Re: **RESUBMISSION OF COMPLIANCE CONDITION DOCUMENTATION RELATED TO A RESIDENTIAL DEVELOPMENT AT ADERRIG (PHASE 3) IN THE ADAMSTOWN SDZ**

SDCC Reg. Ref. SDZ22A/0014

Compliance Submission – Condition No. 19A(i)

Figure 2.1: Area of the site now proposed for taking in charge by the Management Company

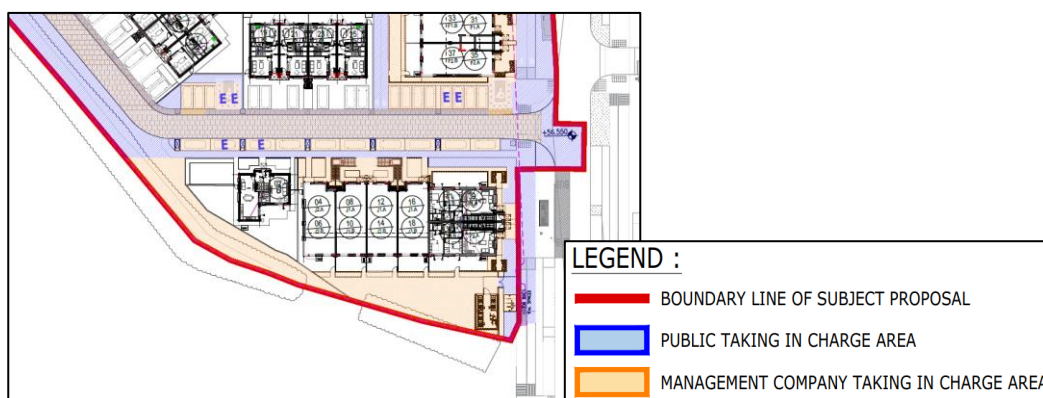
"Not compliant The SDCC Public Realm Section have reviewed the plan identifying external common areas to be retained in private ownership by an owners' management company and have raised concerns with the south-western corner of the site proposed to be taken in charge. The Public Realm Section advise that they would not be able to access this area for maintenance. This was discussed with the landscape architect and agreed that this was an error. This area will need to be under management company maintenance."

In response to the non-compliance decision, please refer to the revised *Taking in Charge Drawing*, prepared by BKD Architects and enclosed under separate cover. As shown in the extract below, the referenced area of open space is now proposed for retention by the Management Company.
